UNITED STATES PATENT AND TRADEMARK OFFICE

APPLICATION NO.	FILING DATE	FIRST NAMED INVENTOR	ATTORNEY DOCKET NO.	CONFIRMATION NO.
10/086,316	03/01/2002	James R. Fore SR.	4287-008	8488

Office Action Summary

DETAILED ACTION

FIG. 1

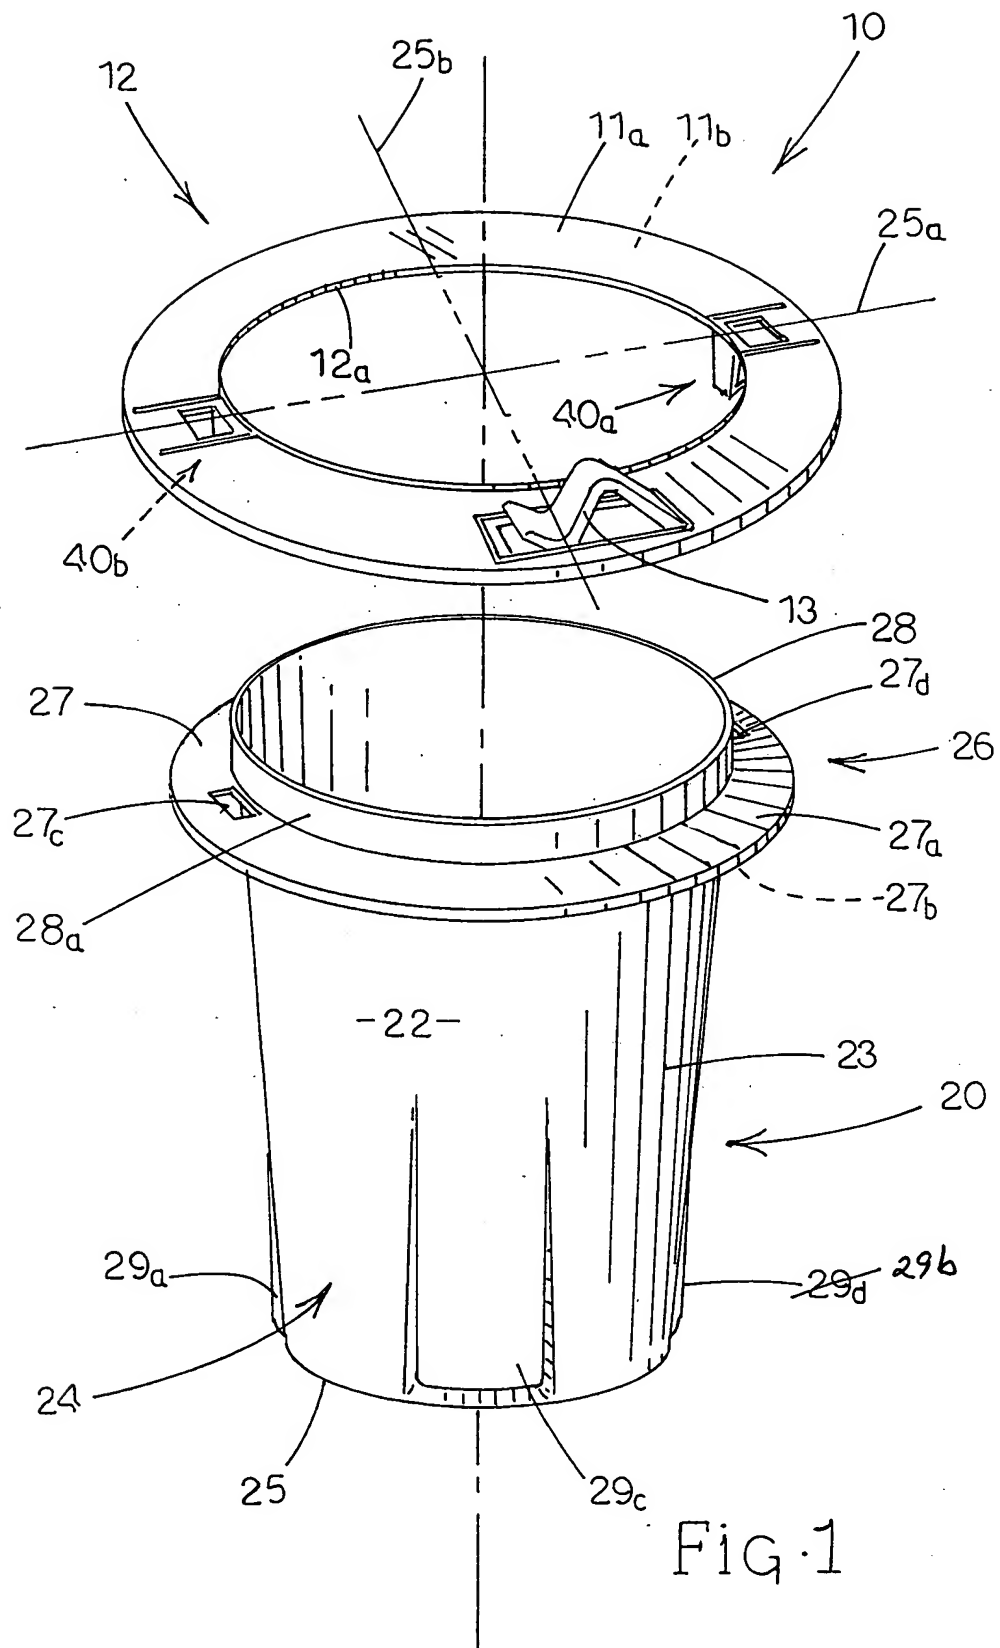
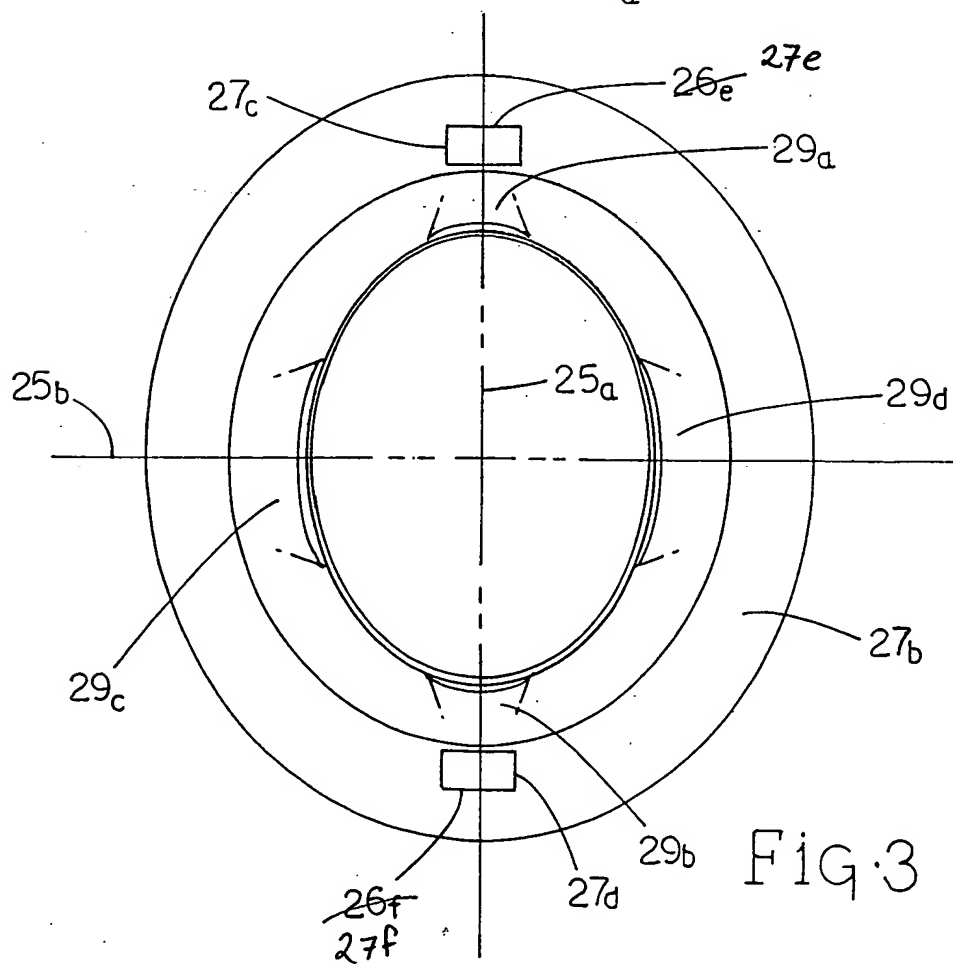
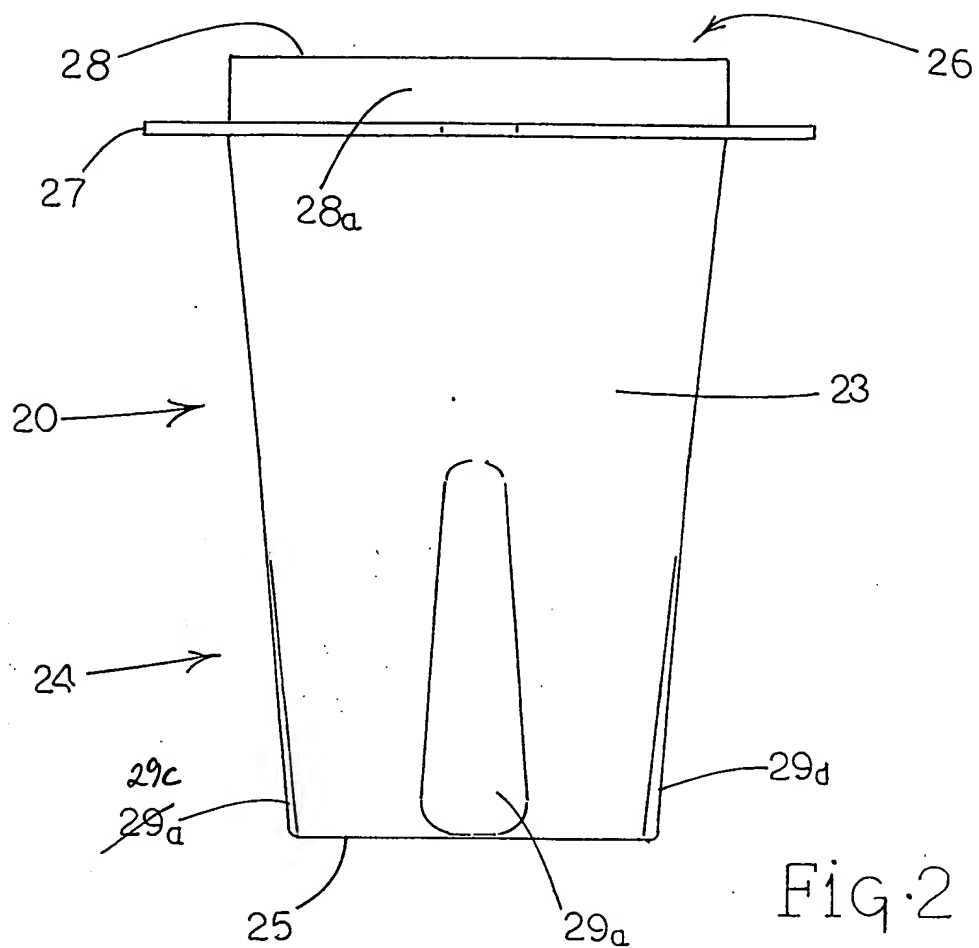
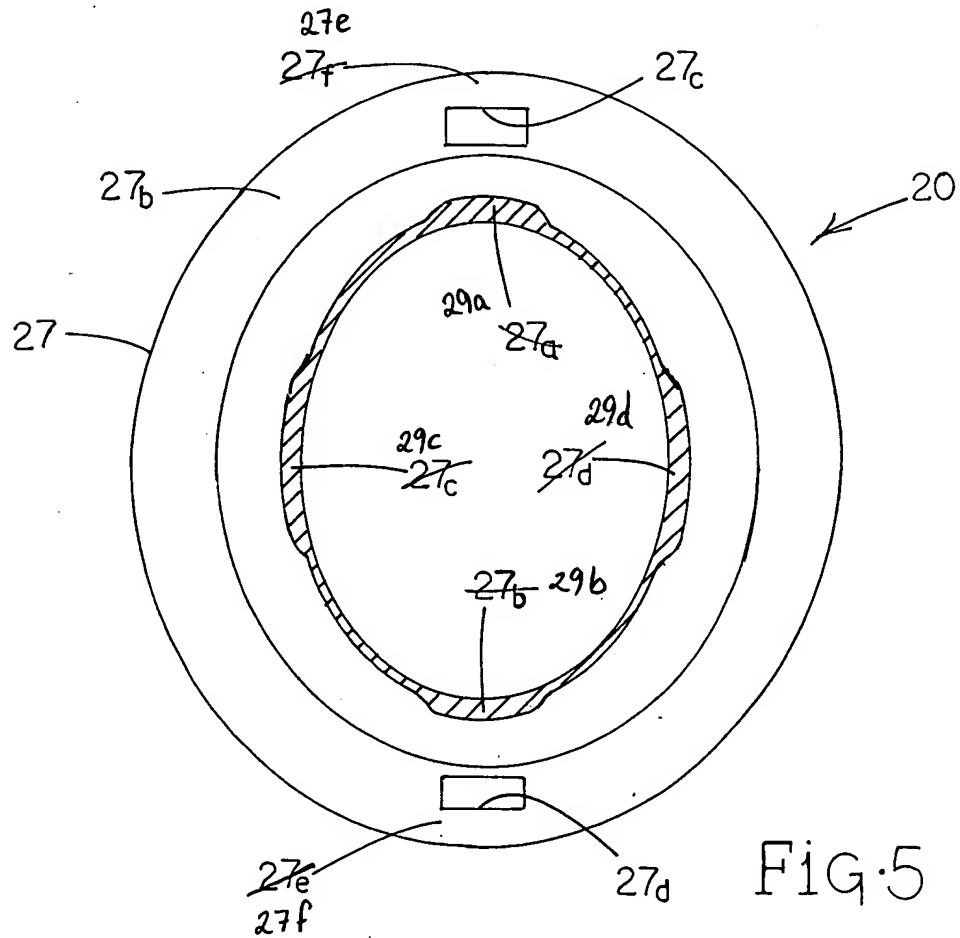
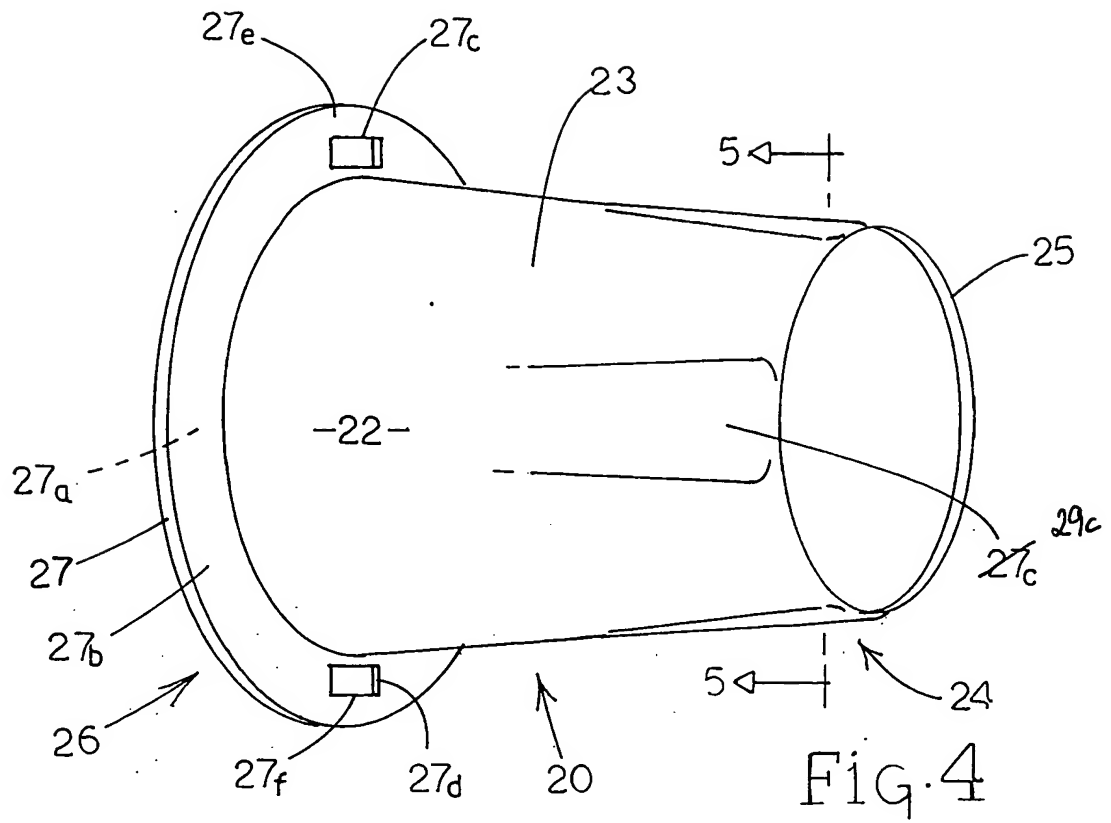
2. The drawings are objected to because: (see attached drawings):
- a. Fig. 1, rib "29d" should be "29b" since the rib is centered on the major axis;
 - b. Fig. 2, rib "29a" should be "29c" since the rib is centered on the minor axis;
 - c. Fig. 3, "26e" and "26f" should be "27e" and "27f", respectively, since they represent the two latch surfaces;
 - d. Fig. 4, the "27c" on the right end should be "29c" since it represents a rib, not an opening;
 - e. Fig. 5, latch surfaces "27f" and "27e" should be "27e" and "27f", respectively, to correspond to Fig. 4;
 - f. Fig. 5, in the cross-hatched area, "27a", "27b", "27c", and "27d" should be "29a", "29b", "29c", and "29d", respectively, since they represent the ribs; and
 - g. Fig. 7, the leader line of "11b" is missing and should point to the surface on the other side of "11a".

3. The drawings are objected to as failing to comply with 37 CFR 1.84(p)(5) because they include the following reference sign(s) not mentioned in the description: “26e” and “26f” (see Fig. 3). A proposed drawing correction, corrected drawings, or amendment to the specification to add the reference sign(s) in the description, are required in reply to the Office action to avoid abandonment of the application. The objection to the drawings will not be held in abeyance.
